MEMORANDUM

Project Name: Strawberry Farm Subdivision
Subject: Site Visit No. 01
Date: September 9, 2024
Time: 9:00 AM – 10:00 AM
Location: 95 Taylor Street, Littleton, MA
Weather: Sunny, 67 degrees
Prepared by: Joshua Ward
Attendees: Mark Gallagher, Seal Harbor Companies (MG)
Joshua Ward, Green International Affiliates, Inc. (JW)

Photo 6:
Soil on site requested for reuse.

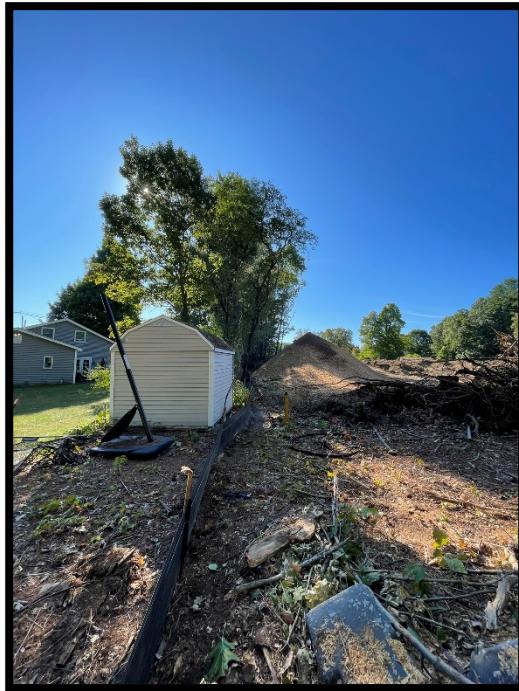
- JW observed the gravel material on site that MG requested to use as a subbase for the roadway. MG would not let JW take a sample to bring back to the office since the material on site was not screened. MG is going to screen it and have it tested at a lab. The gravel appears to have large stones and roots and will require screening (see photo 6).
